### **AGENDA REPORT**

**Case No.** ARB1704-01 **Phone:** 512-990-6306

**SUBJECT:** Discuss and consider an application for an Architectural Waiver to allow the following requests:

#### Horizontal Articulation 9.5.3 (EXCERPT FROM UDC)

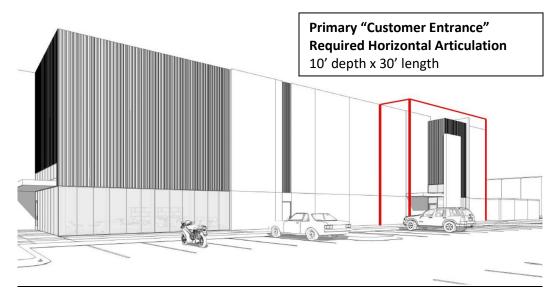
Single-use or multi-tenant buildings equal to or more than 50,000 square feet in gross floor area shall provide horizontal wall projections and/or recesses, at a minimum offset of ten (10) feet in depth and thirty (30) feet in length parallel to the average façade plane at all customer entrances fronting a public right-of-way and along a primary façade.

The proposed secondary "Employee Entrance" is a little more than one half (1/2) the size of the City's required primary "Customer Entrance" for structures 50,000 square feet or larger. The red line is representative of what the city requires per the UDC.

#### **ARCHITECTURAL RENDERINGS**

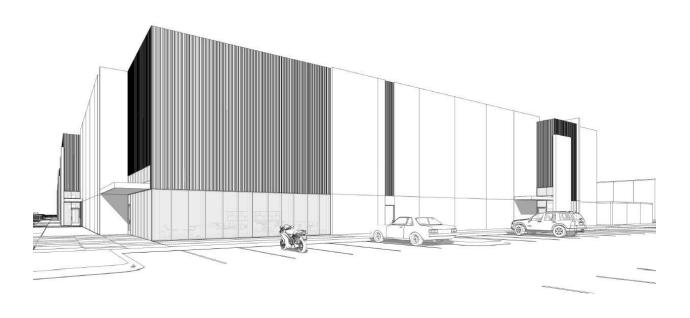
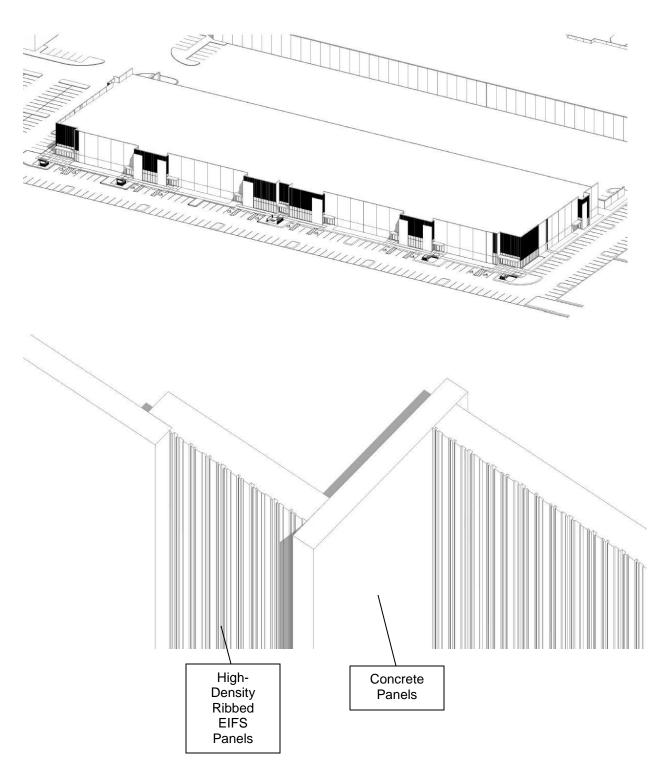
The proposed architectural designs meet the intent of the UDC in terms of providing the following objectives: a mixture of desirable building materials on the exterior building facades; horizontal and vertical articulation; and architectural details and amenities which strengthen the human-scale of larger structures. The staff recognizes the strong design intentions of the project, which respond to the evolving economy and high-tech architecture; the opportunity to showcase the industrial building park due to its proximity to SH-45; and the importance of fostering an engaging human-scale for the large, high-tech structures. As future Campus Industrial (CL) developments are proposed, the City of Pflugerville can observe the architectural trends of the large, contemporary research and development centers and react accordingly.

Staff recommends the approval of the proposed architectural waiver to allow for (1) the utilization of ribbed high density EIFS panels as a lighter weight accent material above entry glazing in lieu of heavy weight primary masonry materials at the 15% required primary masonry minimum and (2) the creation of secondary "employee entrances" along the side facades with a  $6'-8'' \times 16'-8''$  horizontal projection in addition to a 6' wide x 13'-4'' long cantilevered aluminum, instead of the required  $10' \times 30'$  horizontal projections at all "customer entrances" located on buildings more than 50,000 square feet.
